**SECTION 00 90 02
BIDDING AND CONTRACT REQUIREMENTS
ADDENDUM NUMBER 2**

Issued: March 7, 2025

Re: ADDENDUM NUMBER (2) TO THE BIDDING DOCUMENTS FOR

**McHenry County College
2024 Health Science Renovations**
Architect's Project Number: 24-032

3 FLOOR PLAN - LEVEL 2 - NURSING
 3/16" = 1'-0"

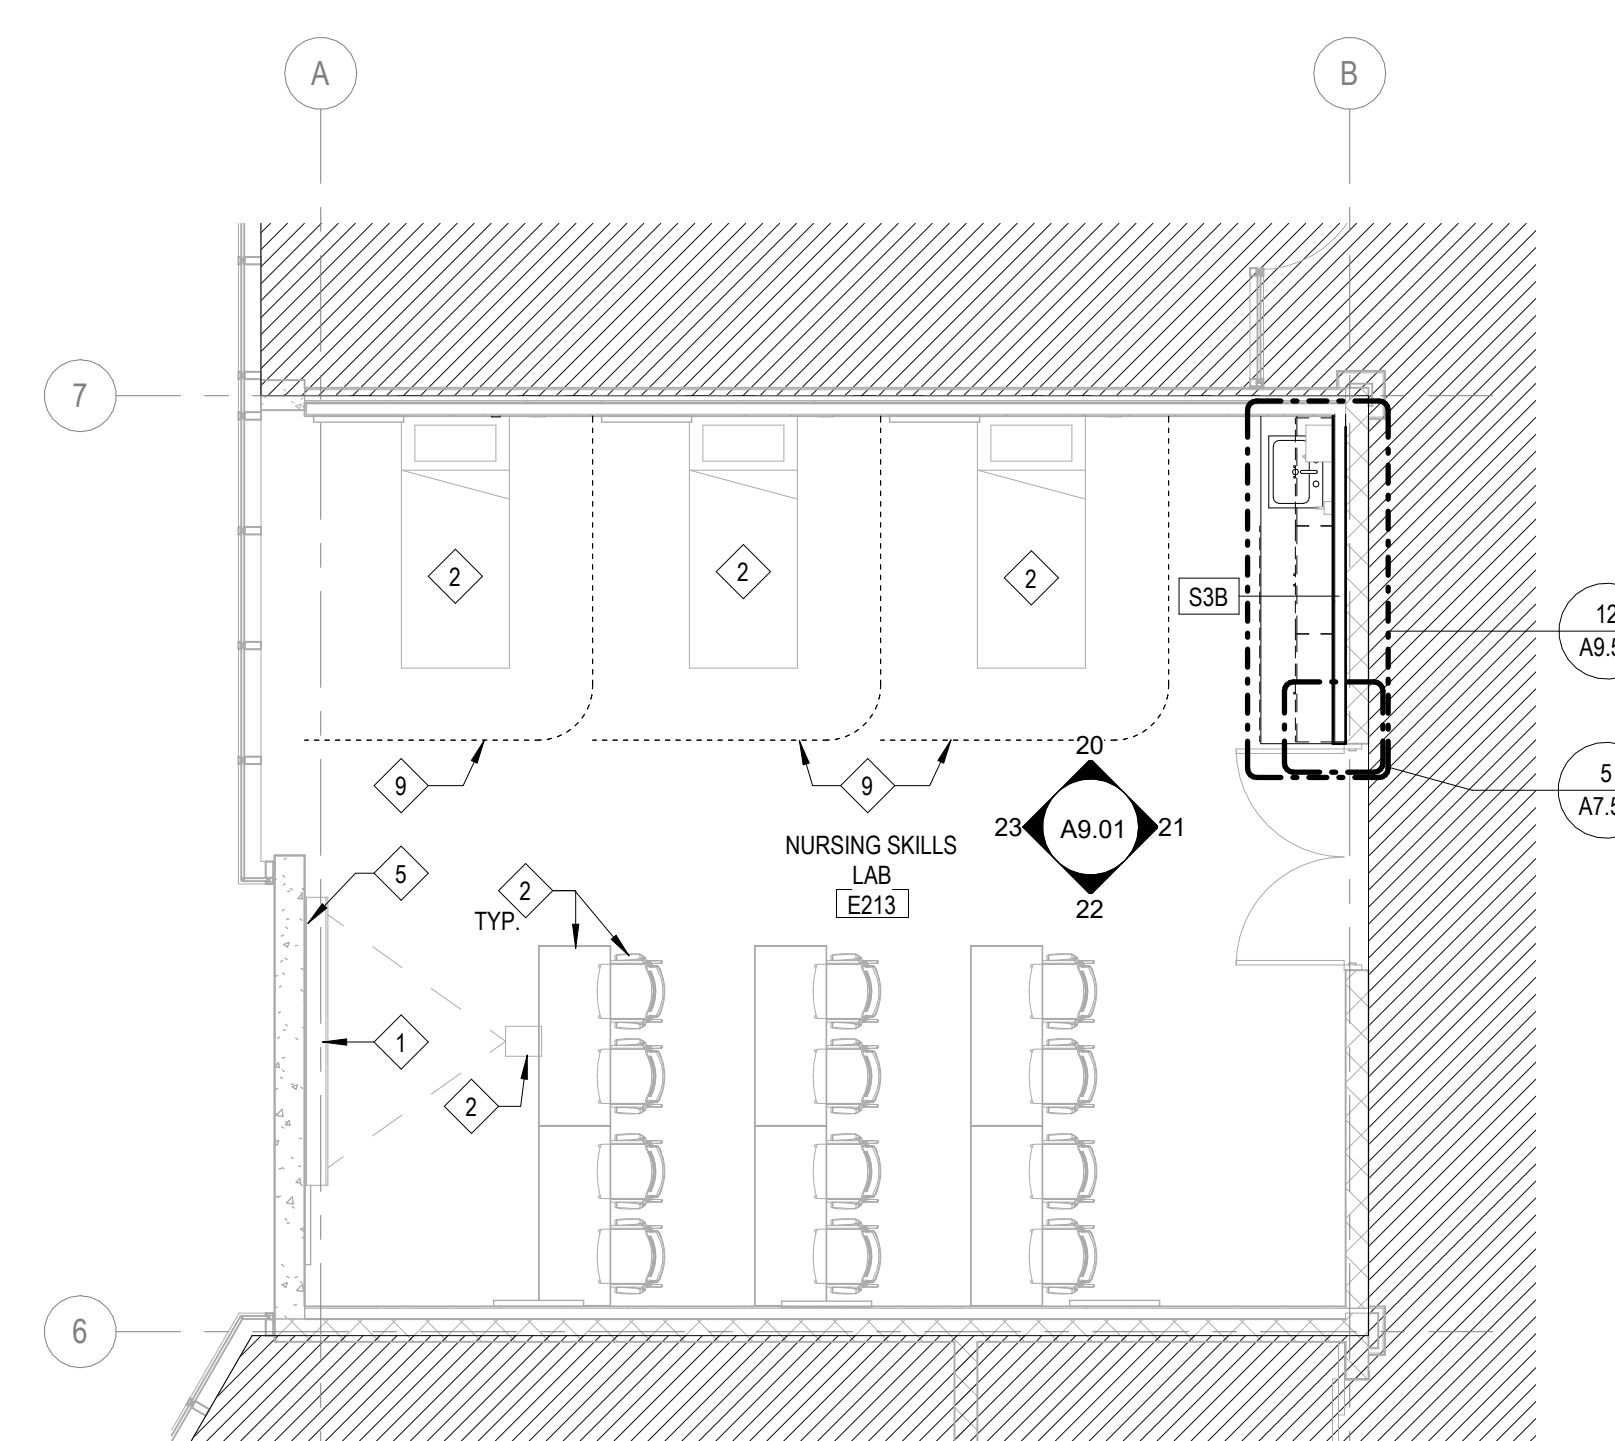
1. A1.10, A10.00
 - a. **REVISE** notes and wall types to clarify extent of lead lined walls required. Refer to RFI responses for additional information.
 - b. **ADD** new work note 11 to clarify wall infill requirements in E116A.

A. RESPONSE: Refer to addendum #2 for wall type clarification.
6. Pre-Bid RFI #5 - (2/A1.10) Floor Plan – Level-1 Radiology calls for wall type S3F, south wall in sonography lab. S3F is not included in wall partition types.

A. RESPONSE: Refer to addendum #2 for wall infill clarification.
7. Pre-Bid RFI #6 - Should the ceilings/ floors/glazing at the X-ray rooms be lead-lined?

- PROVIDE WALL INFILL TO MATCH EXISTING WALL. PER EXISTING DRAWINGS, EXISTING WALL CONSTRUCTION SHOULD BE 3/8" METAL STUD FRAMING WITH (2) LAYERS OF 5/8" GYP BOARD EACH SIDE.

SHEET NUMBER:
A10.00

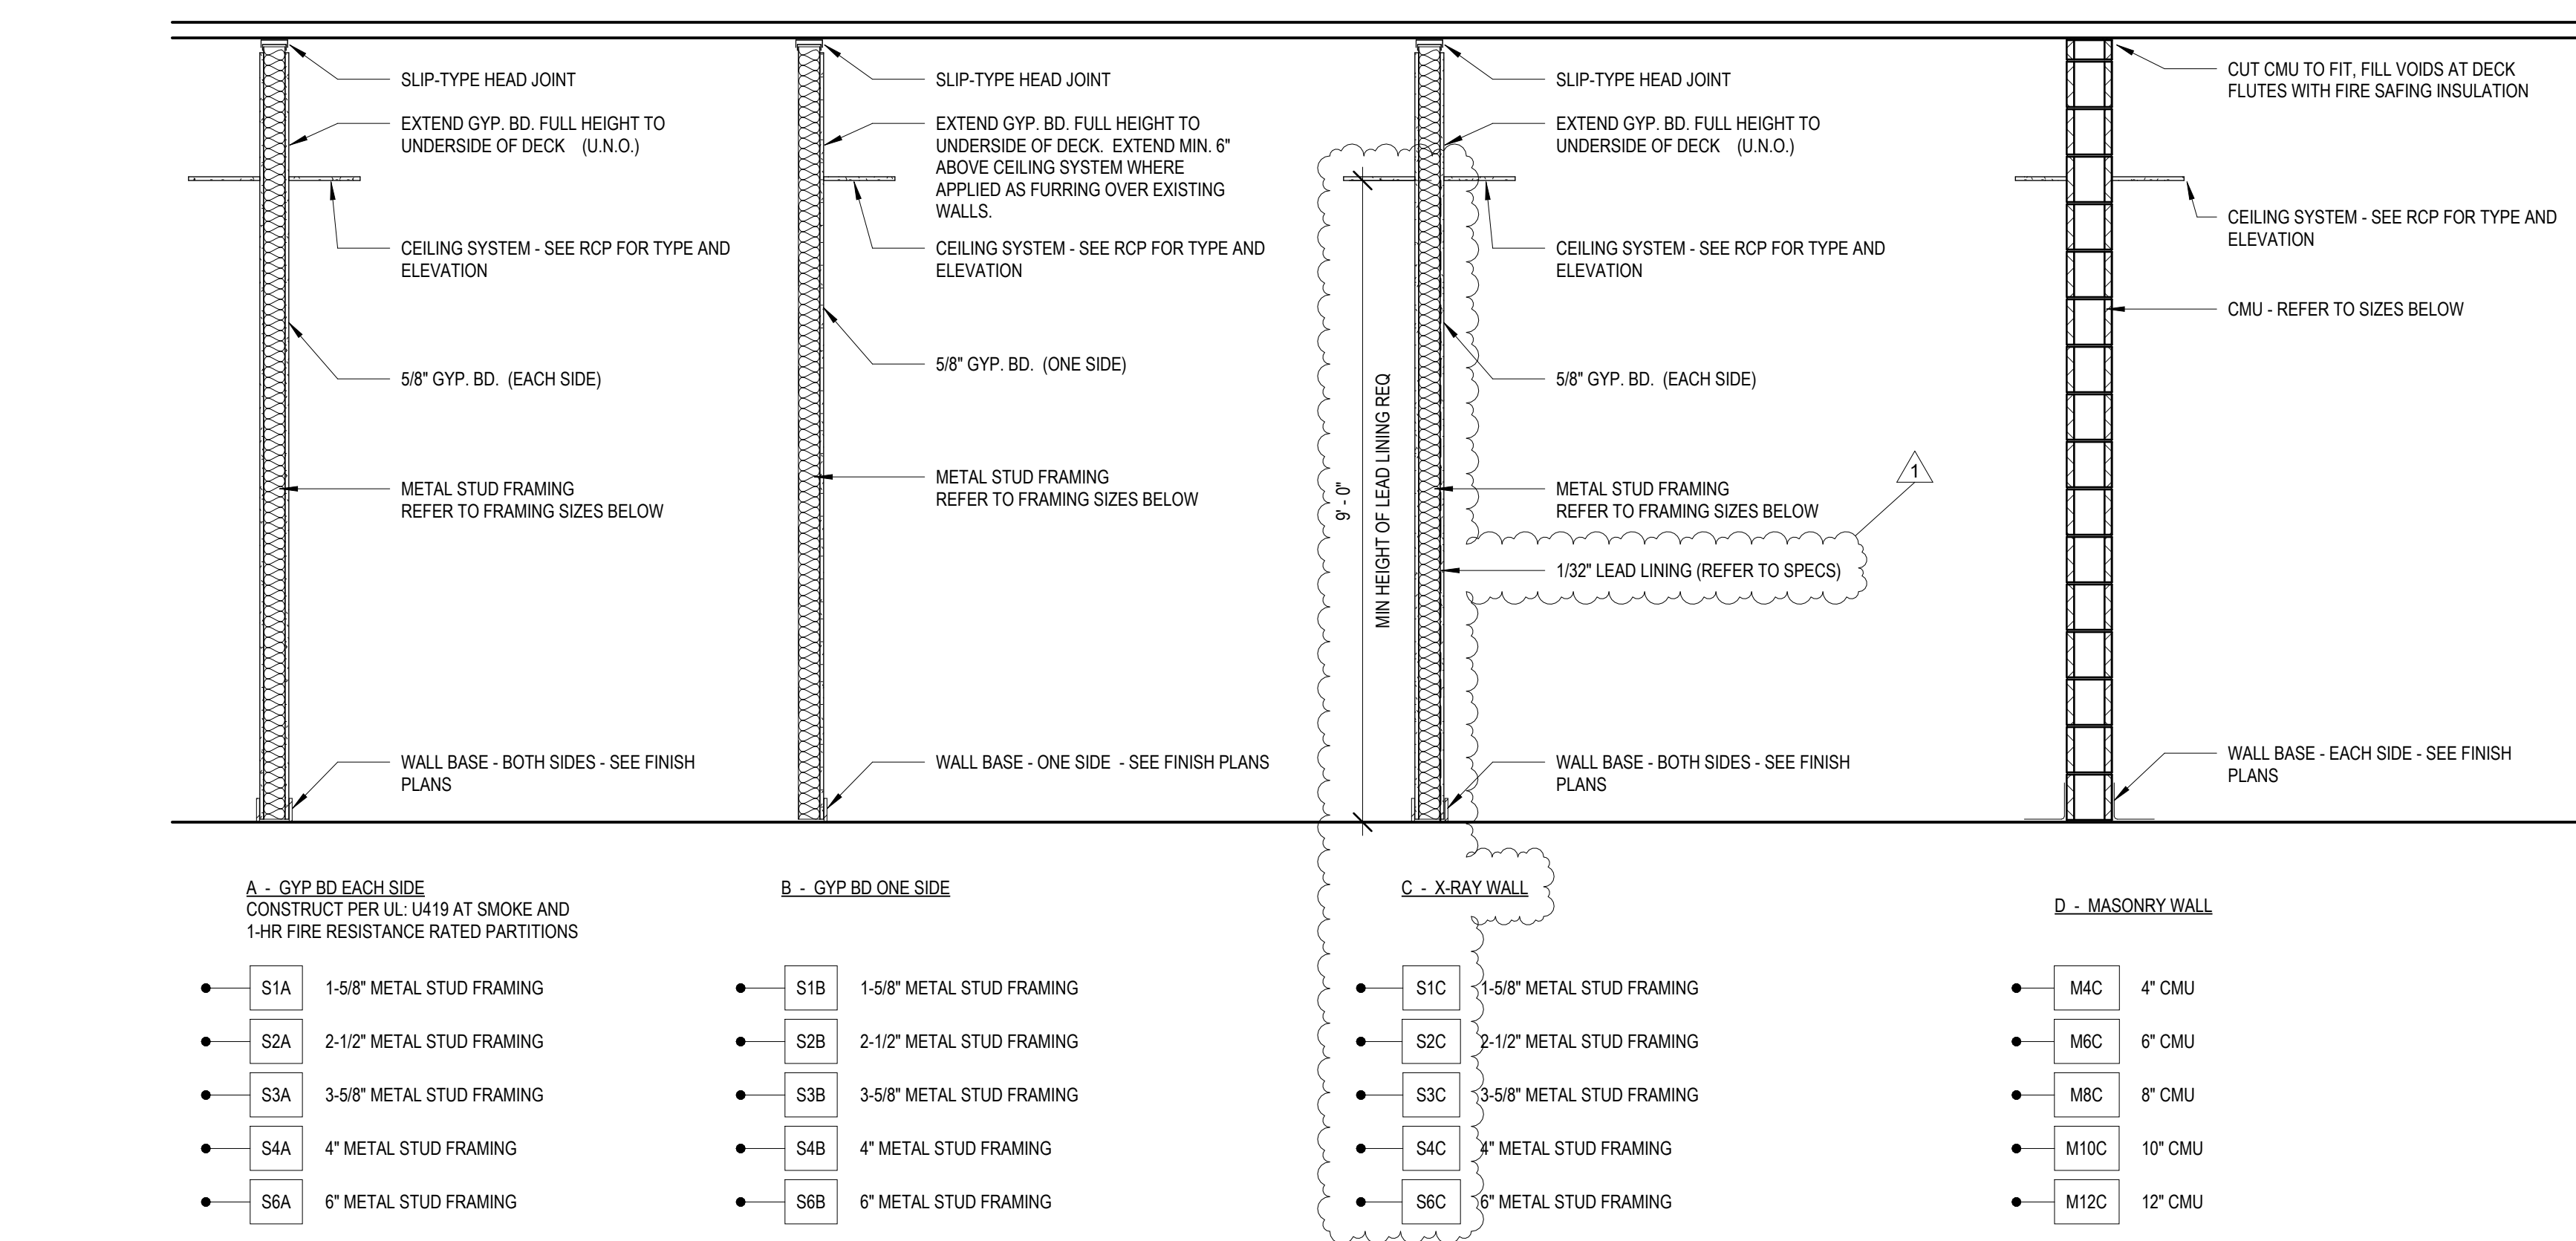
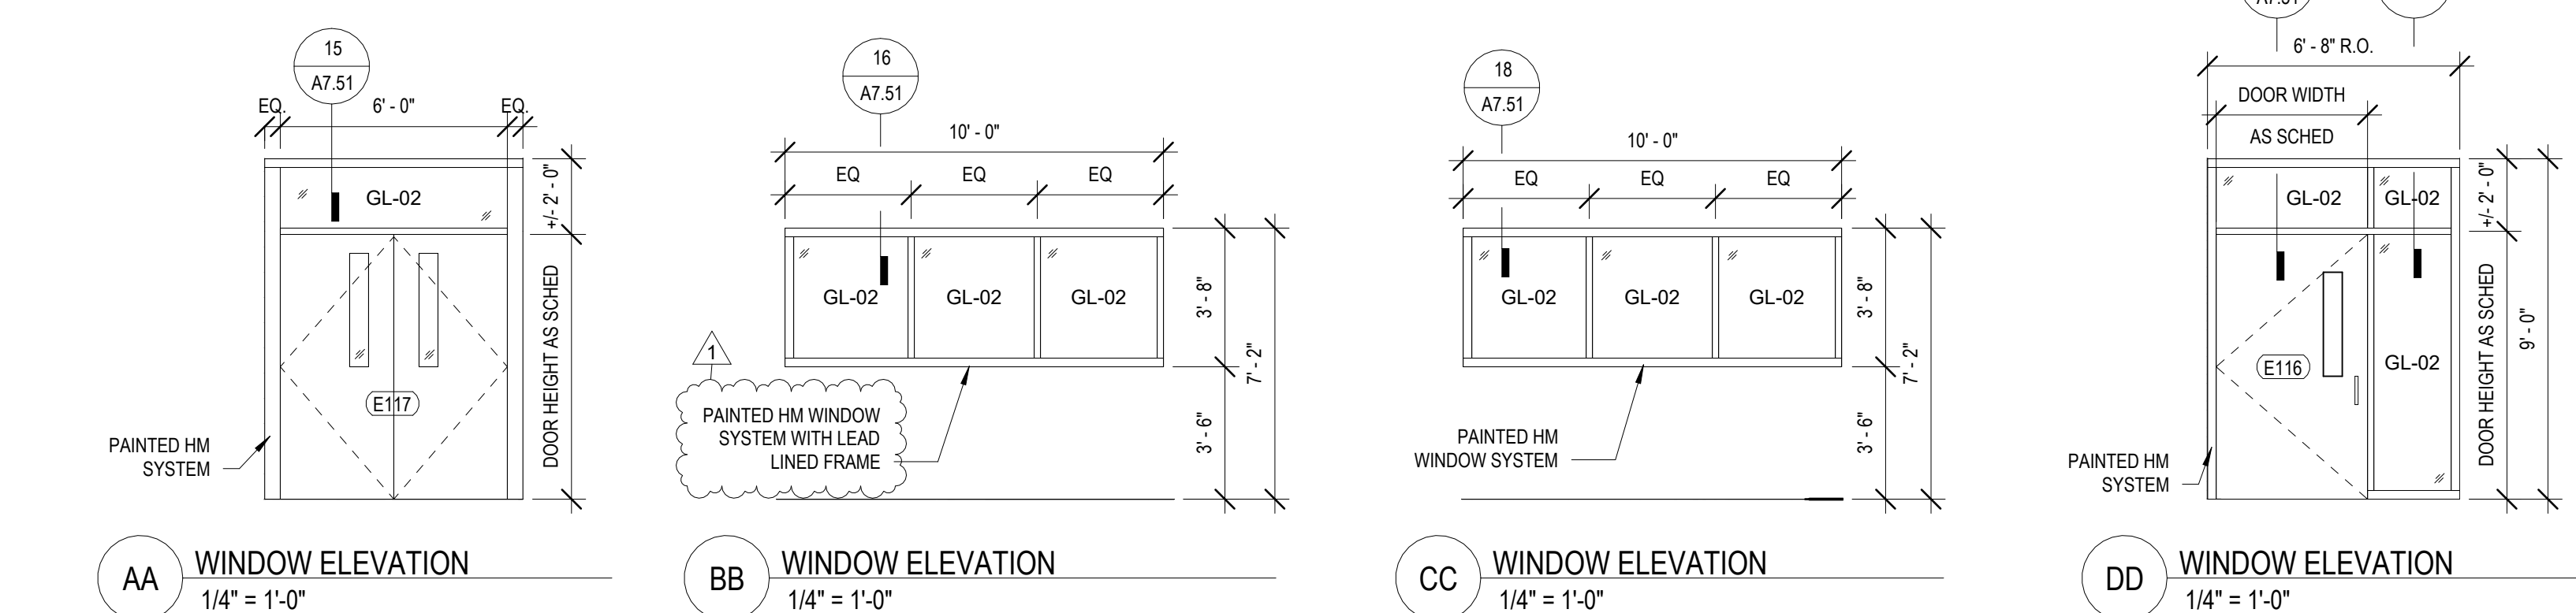
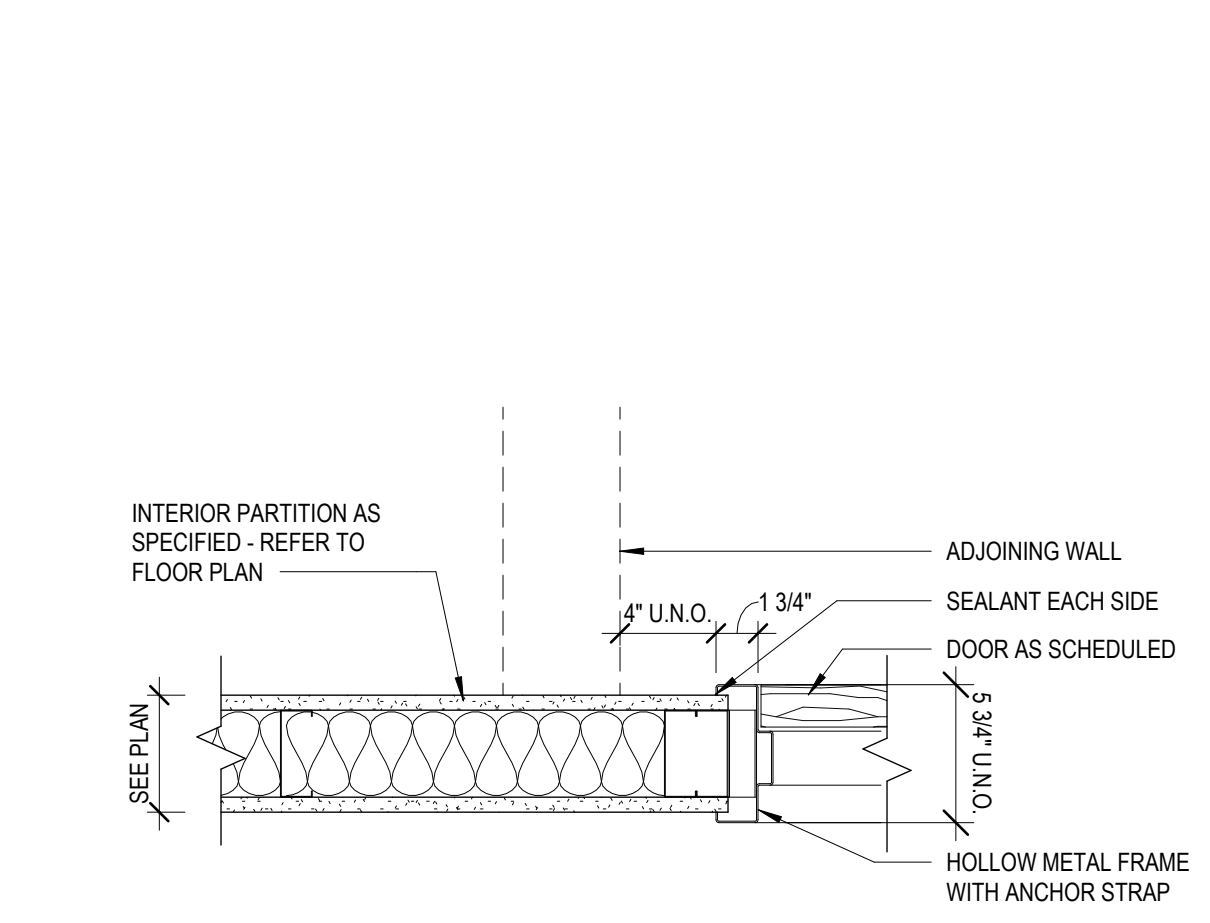
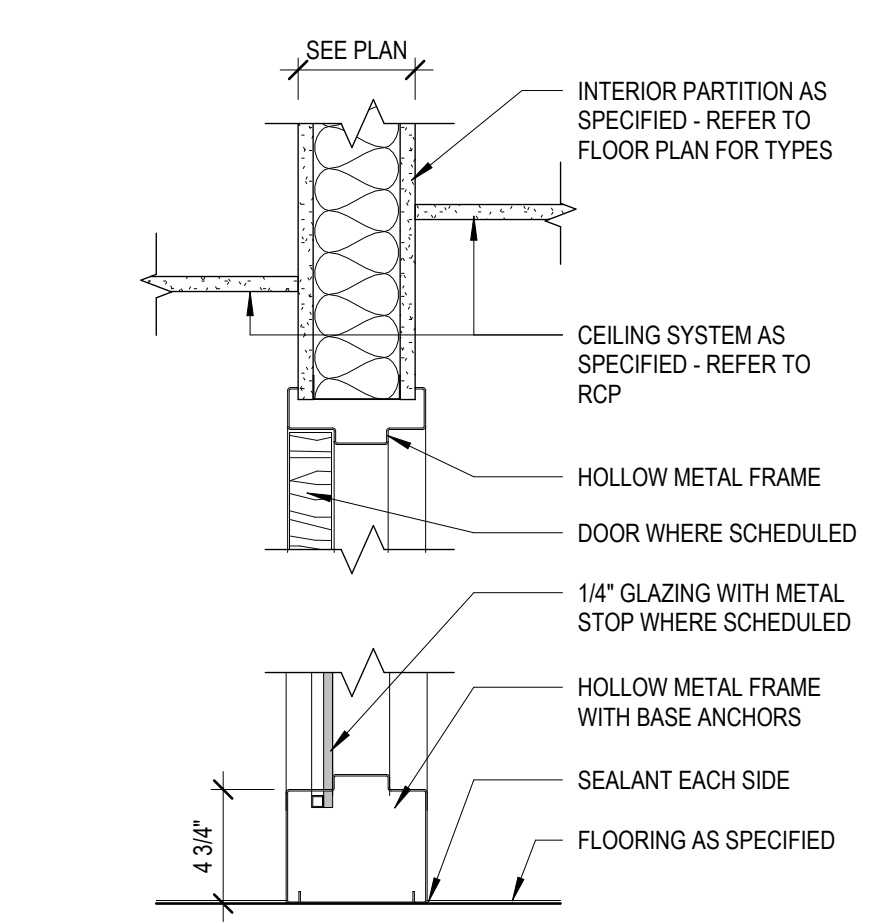
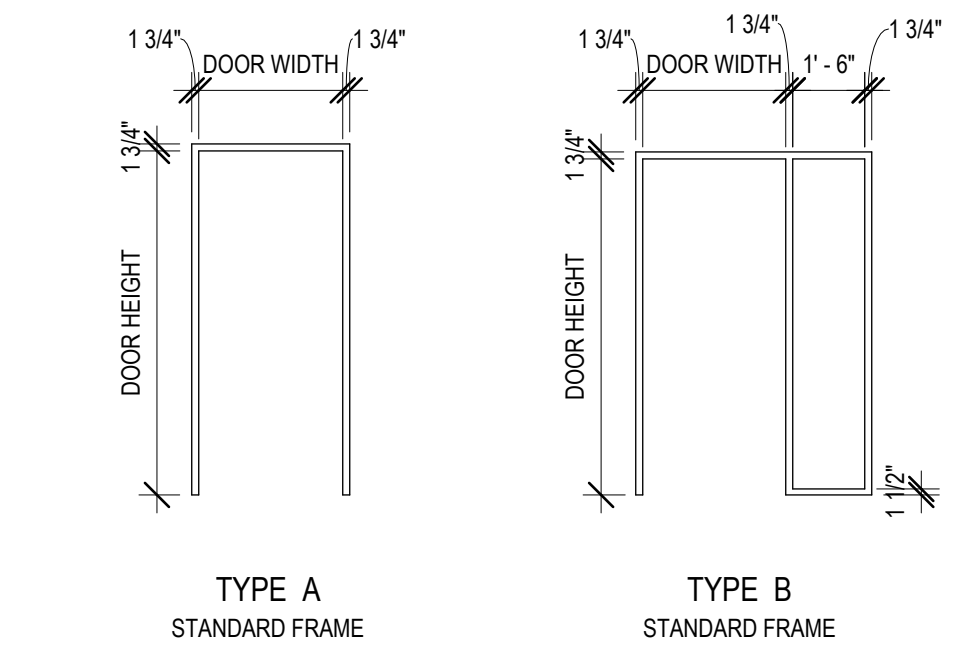
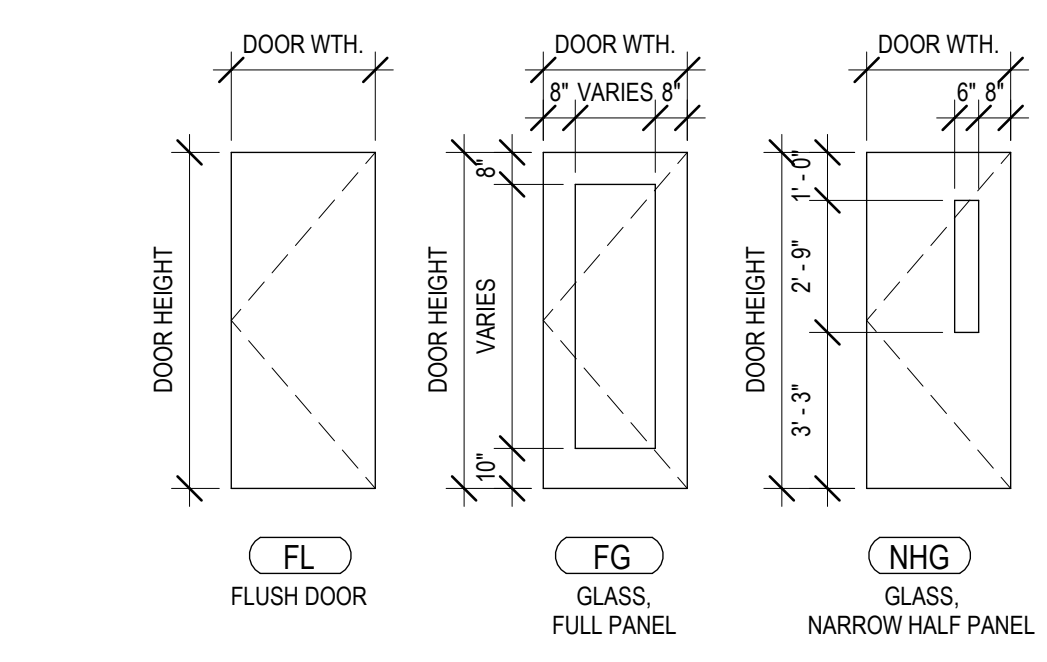
5. Pre-Bid RFI #4 - Please confirm the S3A type C- X-ray wall extent in plans, as there is S3A in wall type A-GYP BD each side and S3A in wall type C- X-RAY wall in partition wall types.

2 LEVEL 01 - LIGHTING - RADIOLOGY
 3/16" = 1'-0"

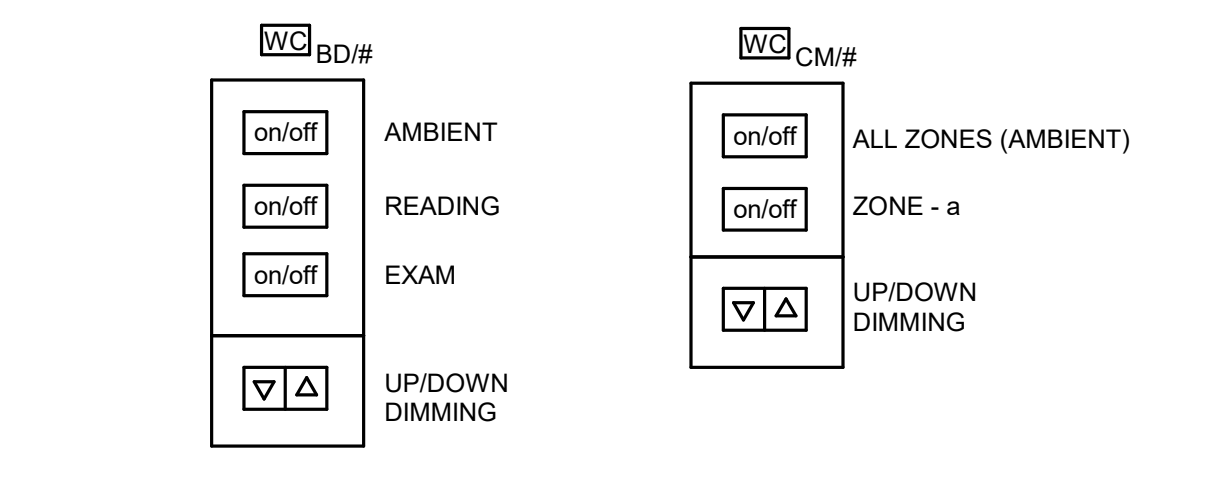
1. E1.10 - FLOOR PLANS -LIGHTING
 - a. **REVISE** lighting layout in the X-Ray Room E116C as shown.
2. E1.20 - FLOOR PLANS -POWER
 - a. **REVISE** raceway WD-1 length in the X-Ray Room E116C as shown.
 - b. **REVISE** keynote #9 as shown.
3. E3.00 - ELECTRICAL ONE LINE DIAGRAM
 - a. **REVISE** one line diagram as shown.
 - b. **REVISE** panel schedule X as shown.
